## ODOR CONTROL FACILITY IMPROVEMENTS PROJECT

Solicitation Number: CO-00704

Job No.: 22-6506

### ADDENDUM 2

2/21/2024 L:\SHARE\ENGINEERING\SAWS\1106-LEON CREEK & BROOKS ODOR CONTROL\14- PRODUCTION\100-BID PHASE DRAWINGS\SHEETS\7-LEON OC PLAN AND SECT - A.DWG

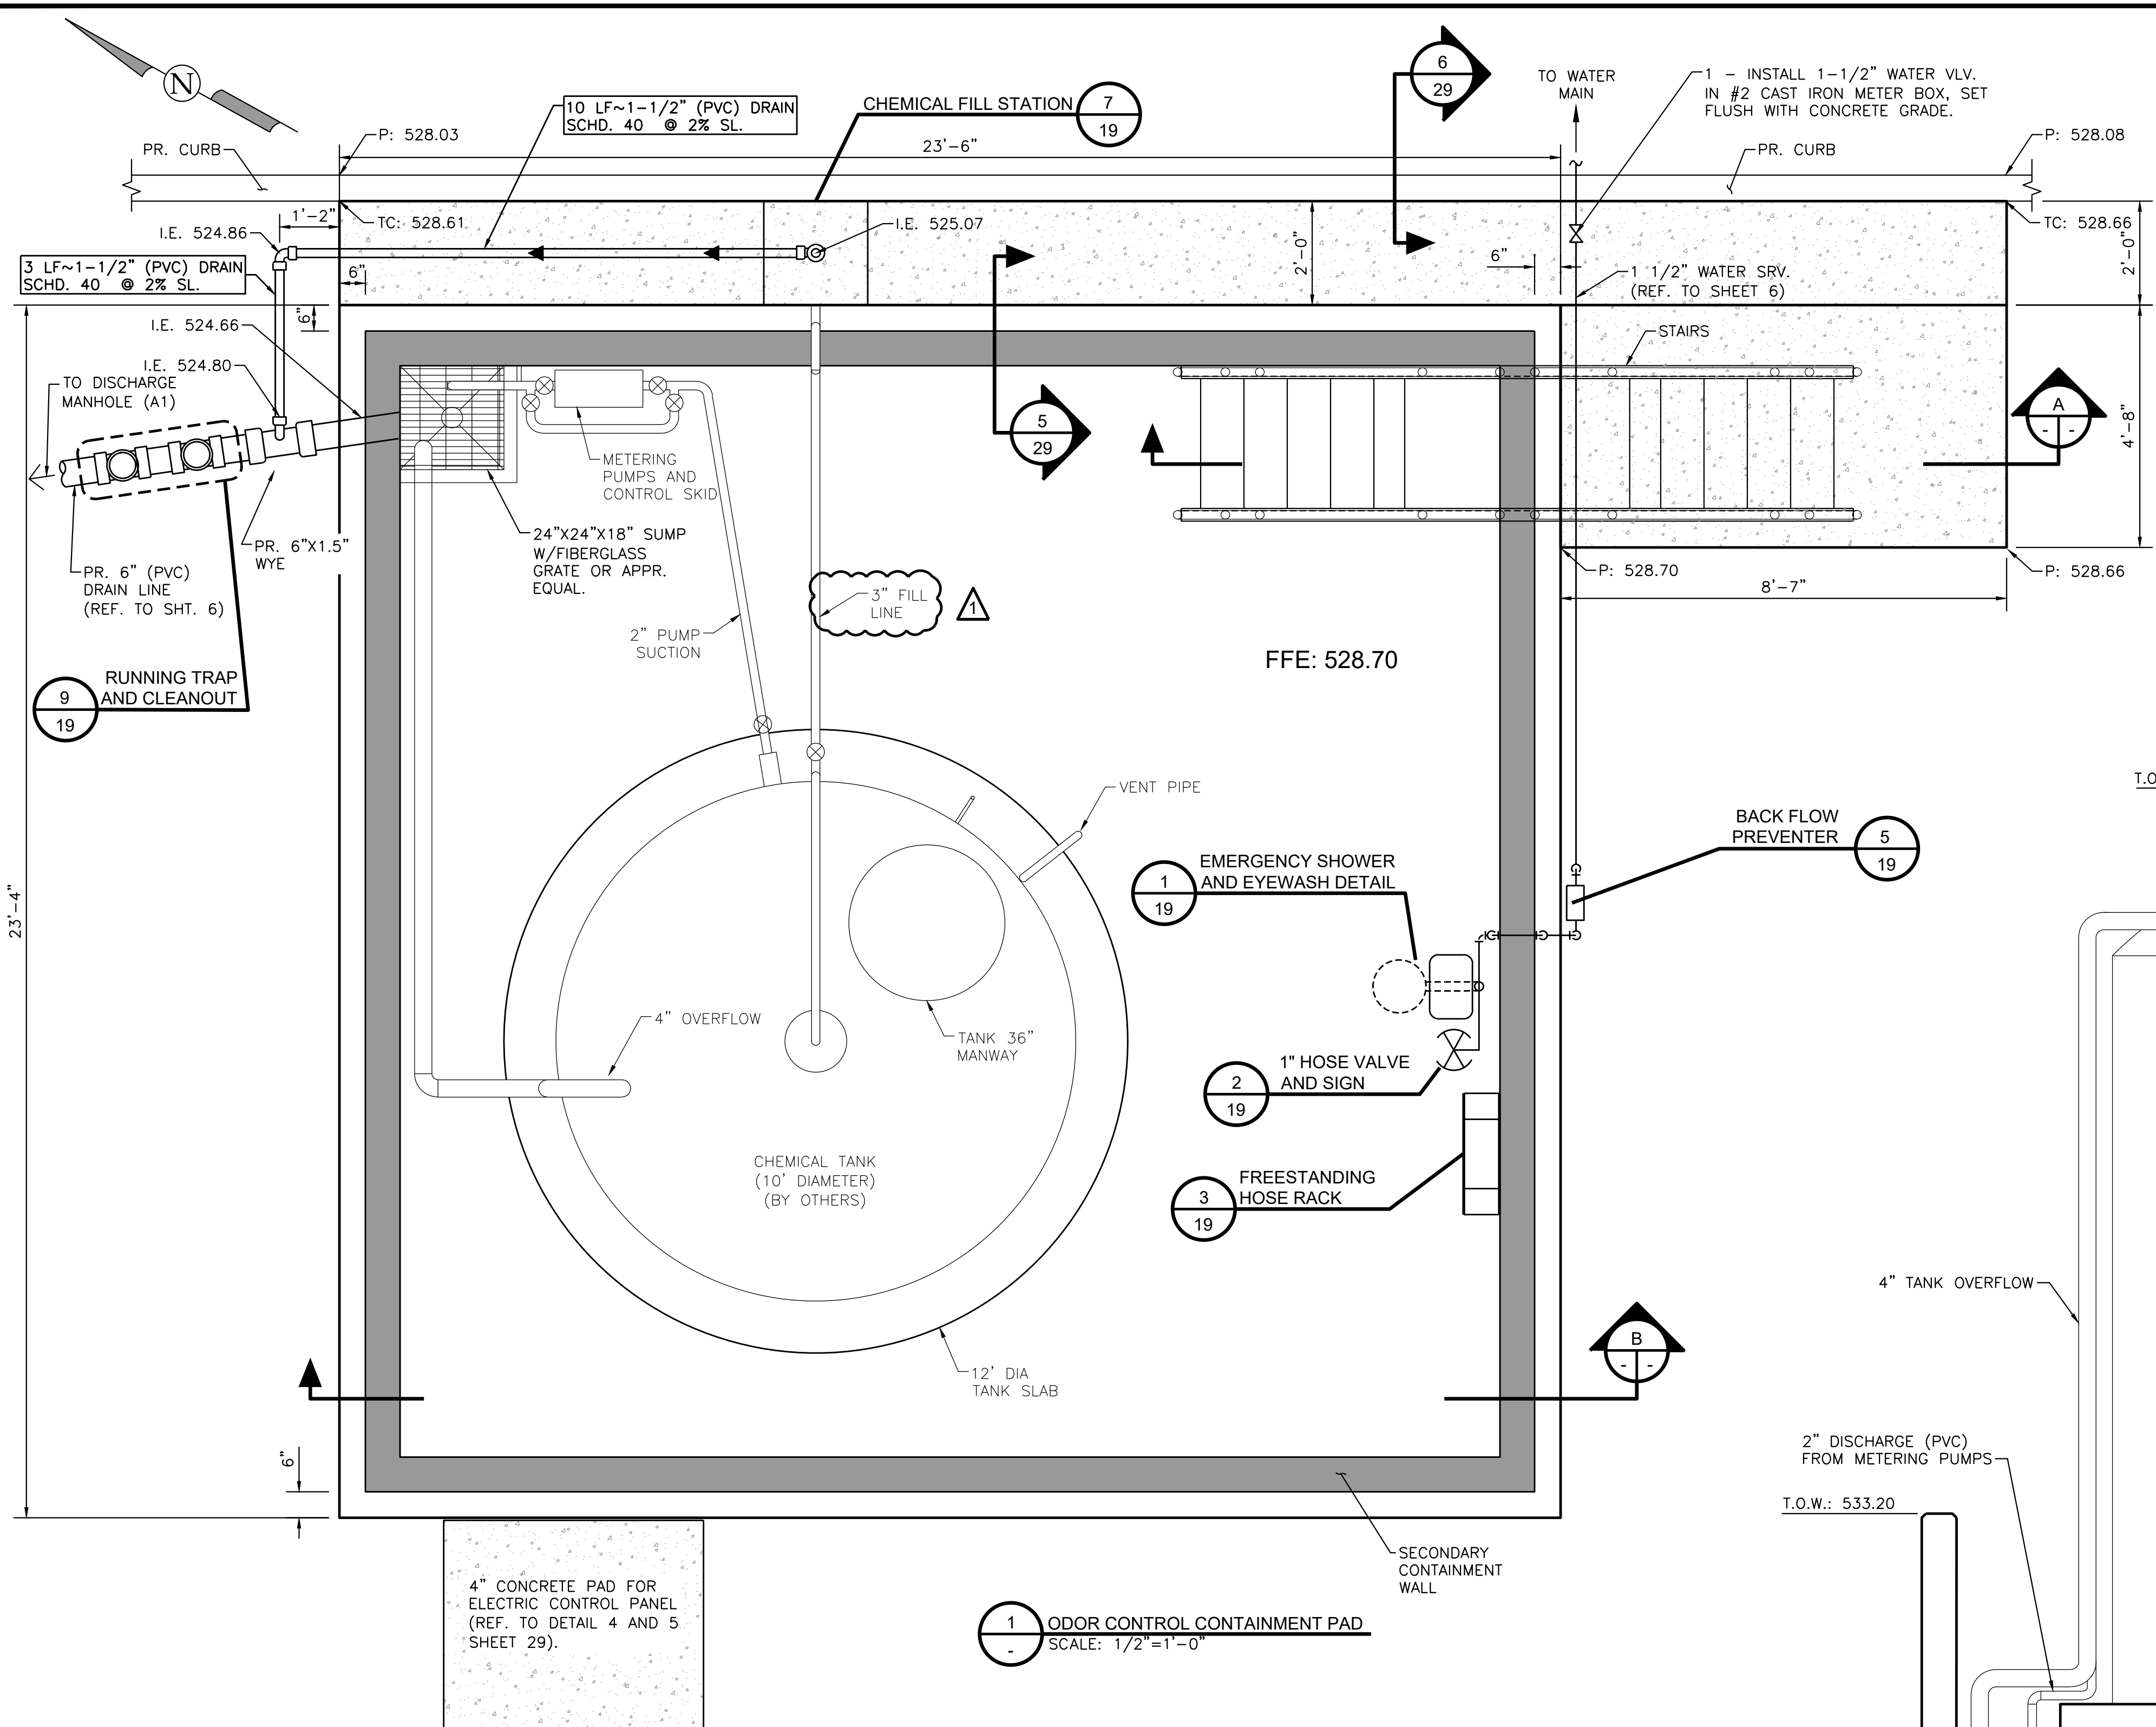
3. Rilling Road Drawing 41-D-501, Liquid Treatment OCF Details, remove in its entirety and replace with the revised version attached to this Addendum.
4. Leon Creek Drawing C7, Mechanical and Structural Plan and Section, remove in its entirety and replace it with the revised version attached to this addendum.

- SHEET NOTES:**
- CHEMICAL STORAGE TANK, CHEMICAL METERING PUMPS, CONTROLS SKID, CHEMICAL INTERCONNECTING PIPING, 3" FILL LINE FROM THE CHEMICAL FILL STATION TO THE CHEMICAL TANK, AND VALVES WILL BE PROVIDED AND INSTALLED BY OTHERS (SAWS VENDOR) UNDER A SEPARATE CONTRACT.
  - ALL OTHER WORK TO INCLUDE SECONDARY CONTAINMENT STRUCTURE, TANK SLAB, DRAIN SUMP, STAIRWAY, EMERGENCY SHOWER AND EYEWASH STATION, HOSE VALVE, FREESTANDING HOSE RACK, CHEMICAL FILL STATION, FILL STATION 1 1/2" DRAIN LINE, FILL STATION BALL VALVE W/QUICK COUPLING, PIPE BOLLARDS, WATER SERVICE LATERAL, AND PVC DRAIN LINE WILL BE PROVIDED BY THE CONTRACTOR.
  - REFER TO SHEET 19 FOR MECHANICAL DETAILS.
  - REFER TO SHEETS 28, 29 AND 30 FOR STRUCTURAL DETAILS.
  - SECONDARY CONTAINMENT CONCRETE STRUCTURE WILL BE PAINTED BY THE FERRIC SUPPLIER UNDER A SEPARATE CONTRACT.
